TSG-RAN Meeting #10
Bangkok, Thailand, 6 - 8 December 2000

RP-000591

Title: Agreed CRs to TS 25.133

Source: TSG RAN WG4

Figure 6.1: RRC Connection Re-establishment Requirement

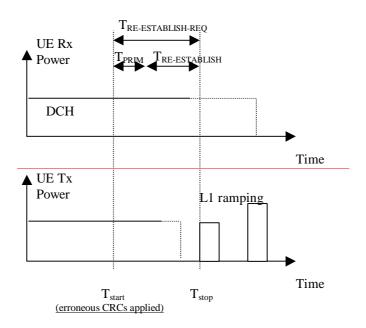
Reason for change: ⌘	This CR proposes changes to section 6.2 RRC connection re-establishment requirements. The current requirements do not consider the number of frequencies a UE have to search in order to do the re-establishment, neither does it consider the time it takes to read system information in the target cell.
Summary of change: ⌘	This CR proposes a new requirement that includes the time it take to read system information and scan several frequencies when the RRC connection re-establishment is performed.
Consequences if not approved: ⌘	If not approved, the current requirements are very difficult for operators to interpret, in order to see how the UE will behave in an arbitrary situation.

~~This is illustrated in Figure 6.1, where the RRC Re-establishment delay ($T_{RE\text{-}ESTABLISH\text{-}REQ}$) is the time between T_{start} and T_{stop}. T_{PRIM} is the time it takes for the CPHY-Out-Of-Synch primitive to detect lost synchronisation and $T_{RE\text{-}ESTABLISH}$ is the time to perform higher layer functionality.~~

RRC Re-establishment is correct if within $T_{RE-ESTABLISH-REQ}$ seconds the UE tries to re-establish the RRC connection with the target cell. $T_{RE-ESTABLISH-REQ}$ is defined in Table 6.2.

Figure X   Illustration of the test case

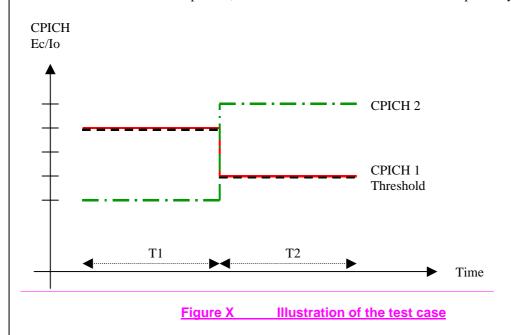
Reason for change:	⌘	To verify that the UE performs sufficient averaging of the intra-frequency CPICH Ec/Io measurements.
Summary of change:	⌘	The test case in 25.133 section A.8.1.3 is updated to ensure that the UE performs sufficient averaging of the intra-frequency CPICH Ec/Io measurements in a fading environment.
Consequences if not approved:	⌘	The requirement that the CPICH Ec/Io intra-frequency measurement shall be averaged over one measurement period will not be verified.

The purpose of this test is to verify that the UE ~~makes~~ performs sufficient layer 1 filtering of the measurements, see section 9.1, which are the base for the event evaluation. The test is performed ~~correct reporting of an event~~ in ~~a~~ fading propagation condition~~s~~. This test will partly verify the requirements in section 8.1.2.

The test parameters are given in Table A.8-6 and A.8-7.In the measurement control information it is indicated to the UE that event-triggered reporting with Event 1A and Event 1B shall be used. The test consists of two successive time periods, each with a time duration of T1 and T2 respectively.
